COLUMBUS CONSOLIDATED GOVERNMENT
Georgia's First Consolidated Government

Addendum No. Three
Transit Bus Wash System
RFB No. 21-0010

TRANSIT BUS WASH SYSTEM
RFB No. 21-0010

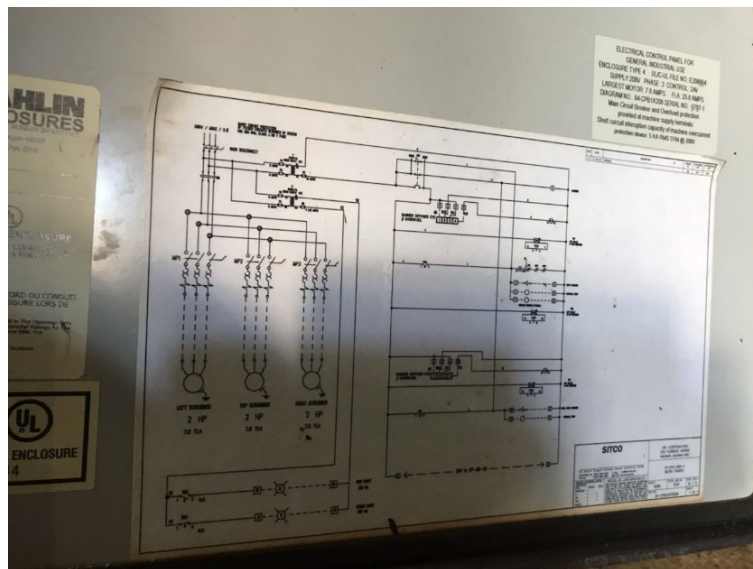
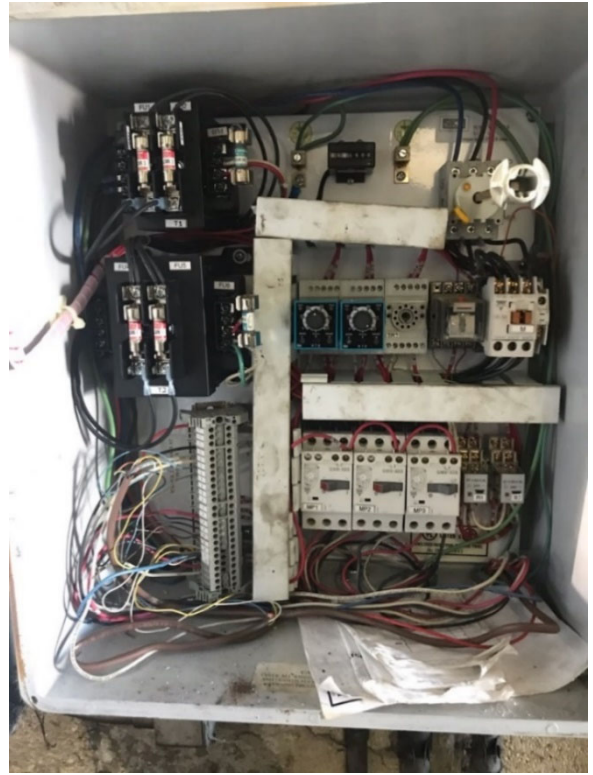
3. Question: *"Ref. Spec. Item 3.J; Tire Guides on Page 25 – are skid plates required? These are recommended to enable the tires to properly align with the tire guides."*

Response: **Yes.**

DETAILED DESCRIPTION	VENDOR'S RESPONSE:
3. The system has angled entry at the entrance. Ends of rails are capped and all headings are smoothly finished to prevent tire damage. Brackets supporting pipe shall be made of minimum of 3/8" steel plate that are welded to concrete imbedded cleats or anchor bolted to the concrete. Additionally, METRA requires skid plates with the dimensions between 4' wide x 4' long.
